TRANSMITTAL SHEET

DOCUMENT DESCRIPTION: Site Plan showing proposed well locations (MW-4 through MW-6) at Chevron Service Station #9-3322 located at 7225 Bancroft Avenue in Oakland. Well installation has been scheduled for November 30, 1998.

SITE PLAN
Chevron Service Station No. 9-3322
7225 Boncroft Avenue
Oakland, California

FIGURE
2

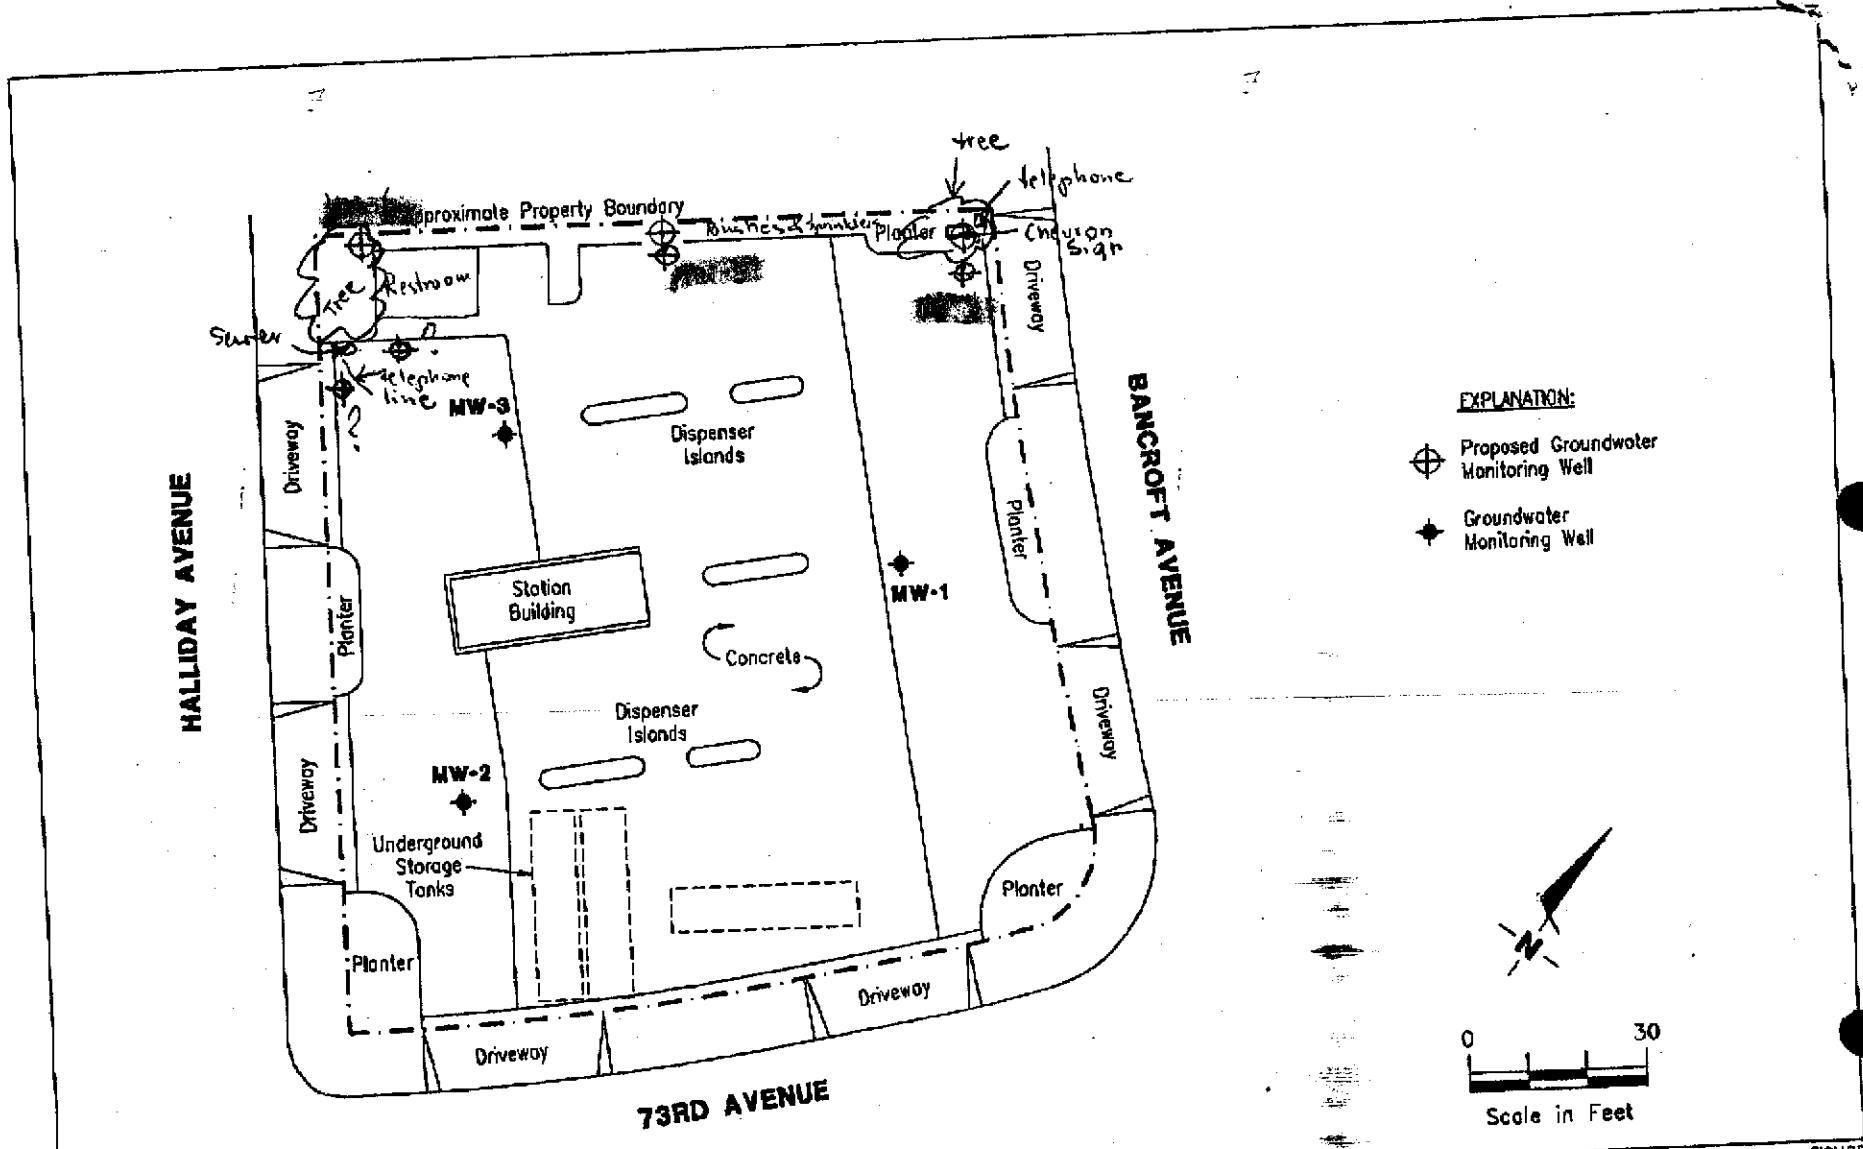
There is a telephone booth, Chevron sign and a large tree in the area of proposed well MW-4. Therefore, well MW-4 needs to be moved approximately 7 feet to the southeast. The planter near proposed MW-5 location is only 1.5 feet wide with many shrubs and a sprinkler line along the planter and is bordered with a fence to the northwest. Therefore, proposed well MW-5 needs to be moved approximately 4 feet southeast. The planter in the western corner of the site (in the area of proposed well MW-6) is fenced off. There is a large tree on this planter and a restroom building next to the planter. Sewer and telephone lines are adjacent to the planter. It appears, that well MW-6 could be installed onsite in one of the locations shown with question marks on the attached Site Plan. However, these locations are only approximately 25 feet away of well MW-3, therefore, a well installed in one of these locations would provide redundant data and does not appear to be necessary.
